Proposal Request

PROJECT: *(name and address)*
AWSOM
Bentonville, Arkansas

PROPOSAL REQUEST 050

PROPOSAL REQUEST 50 BRIEF

① TECHNOLOGY - LEVEL 1 RCP - AREA B
1/8" = 1'-0"

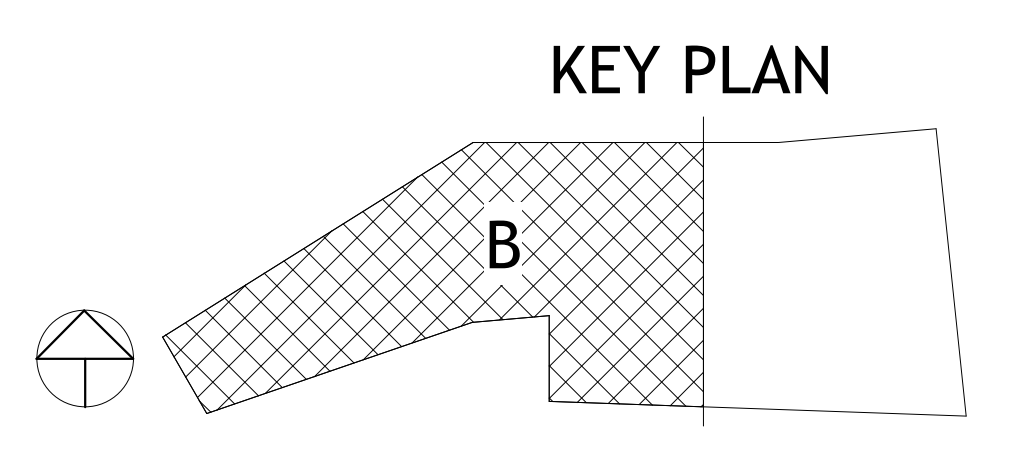
- a) Refer to Revised Sheet **TN201B**, with original issue date 02.24.2023 and revised date 04.25.2024.
 - Revised conduit pathway crossing over Services Corridor #C15.4. Conduits are to be continuous over hard-lid ceiling in-lieu of fire-rated sleeves. Contractor to ensure that fire-rating meets the project requirements.
- b) Refer to Revised Sheet **TN203A** with original issue date of 02.24.2023 and revised date of 04.25.2024.
 - Revised cable tray originating from Data #3102 to be continuous conduits from Corridor #C31.2 to Circulation Area #C13.6.
 - Replaced cable trays over hard ceiling in Public Lobby #3000 with 4" conduits. Refer to drawing for exact quantity.
